Long  
Island  
Power  
Authority

LSNRC-2017

Additional Information Related to  
Decommissioning Plan Change/Clarification  
Liquid Radwaste Processing System  
Shoreham Nuclear Power Station - Unit 1  
Docket No. 50-322

FIGURE 1 - EXISTING LIQUID RADWASTE SYSTEM - 011

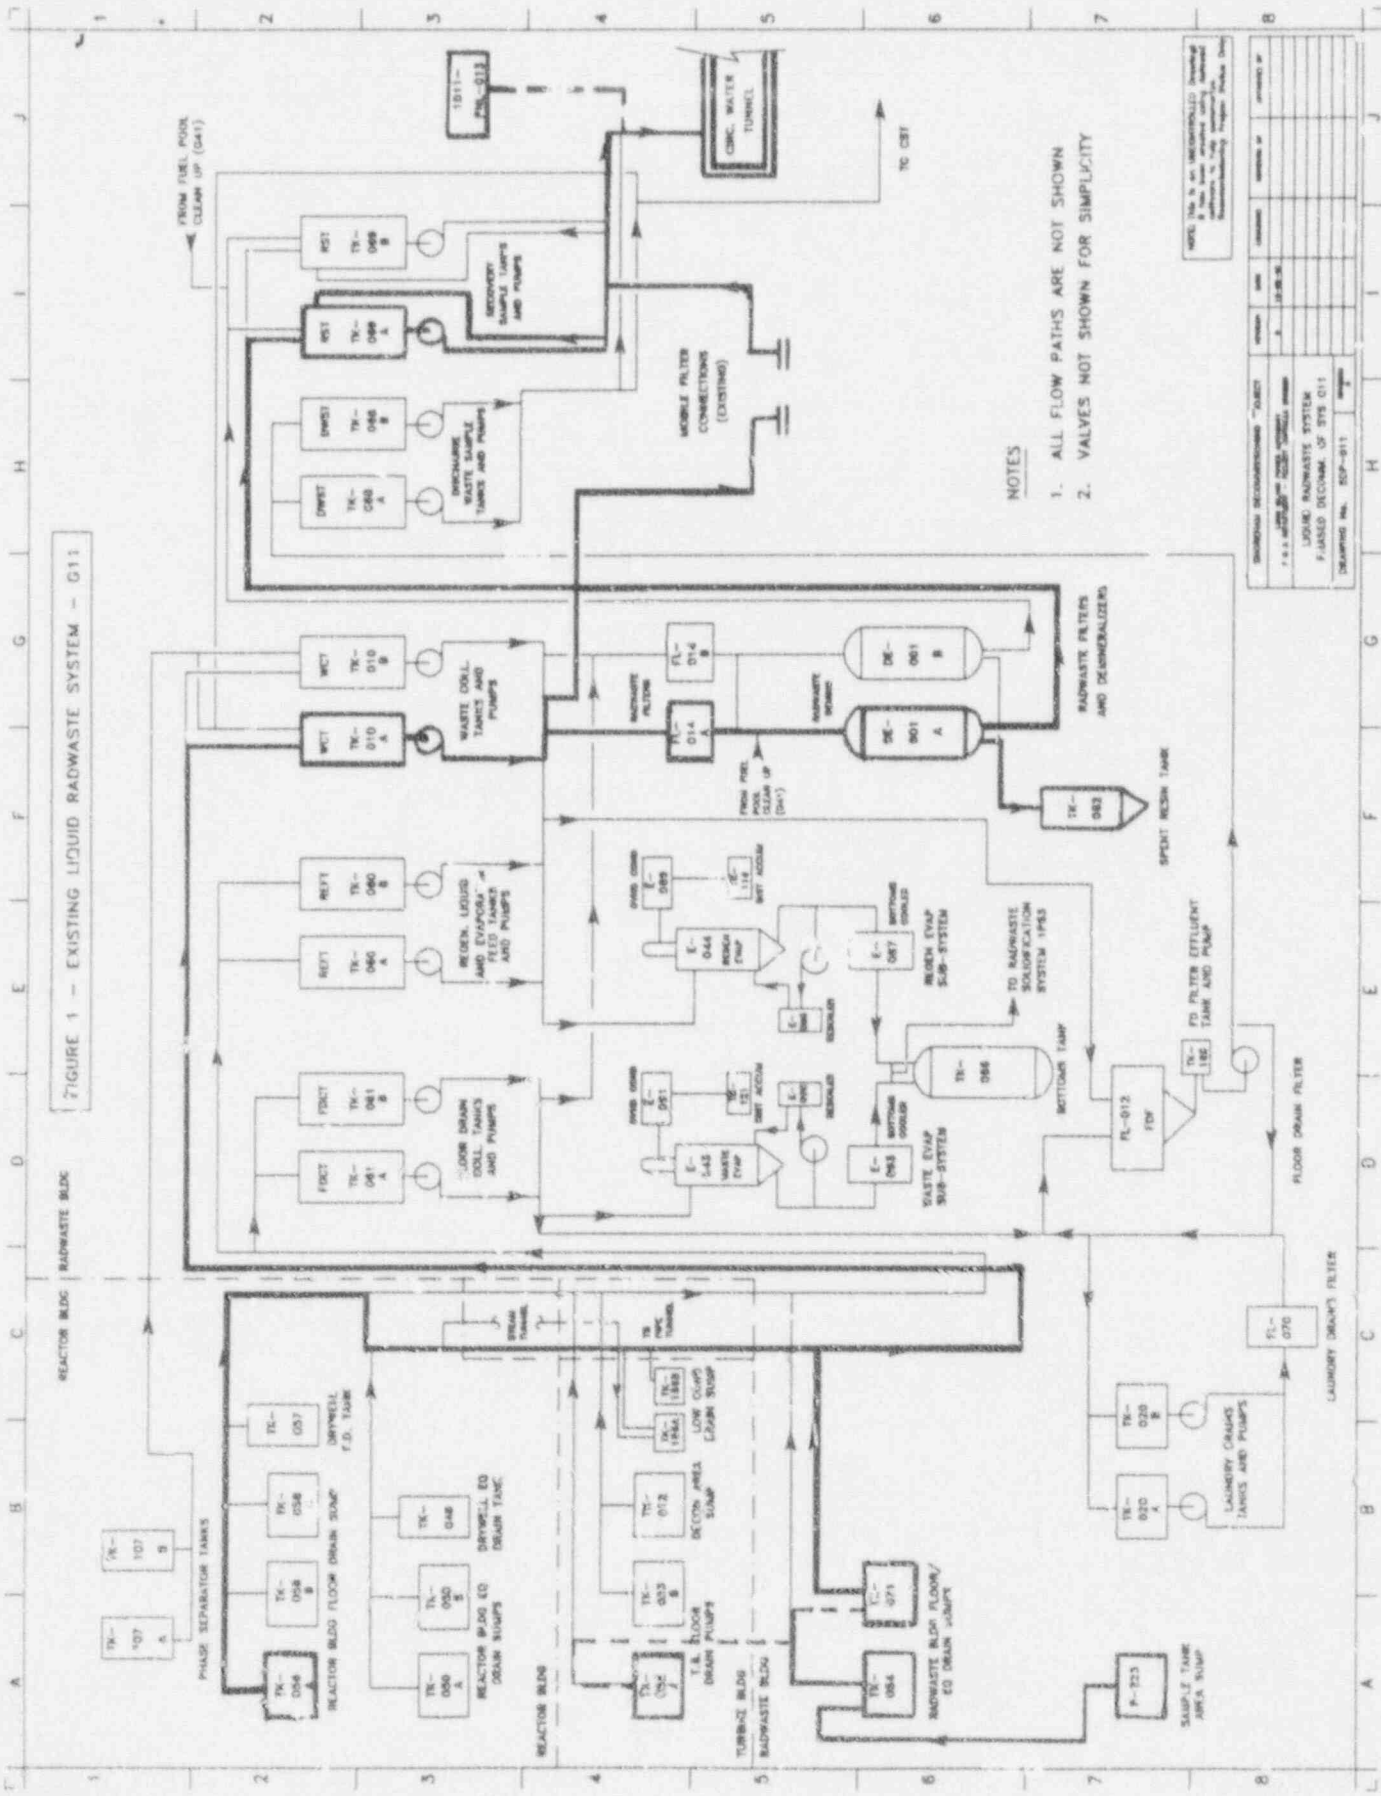
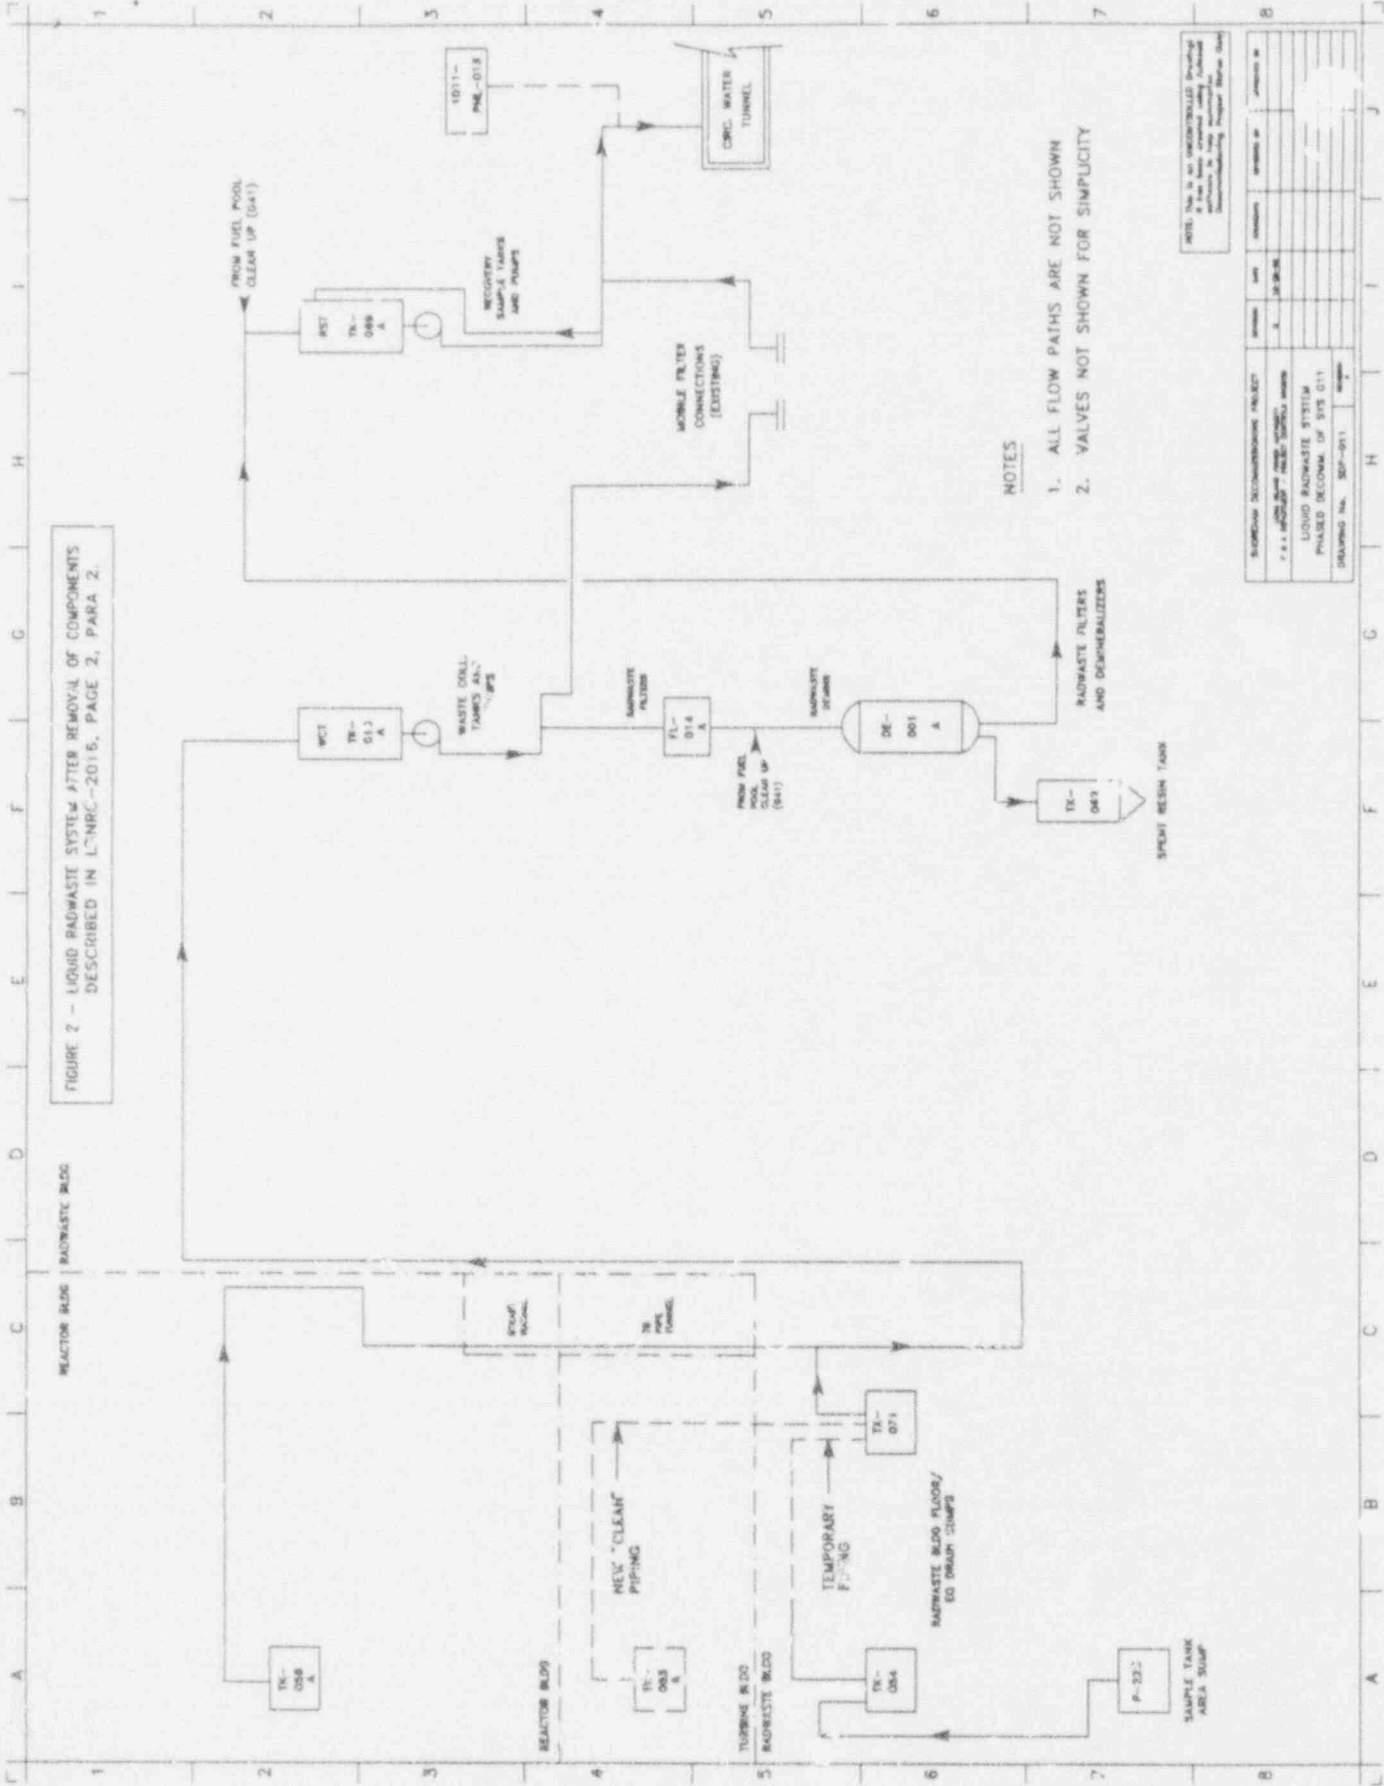
Figure 1 depicts the Liquid Radwaste Processing System (G11) configuration as currently installed. Figure 2 depicts the configuration of the installed plant equipment which will be utilized to hold, recirculate, sample and process liquid radwaste after the Phase 2 components, as identified in reference (1), are decommissioned.
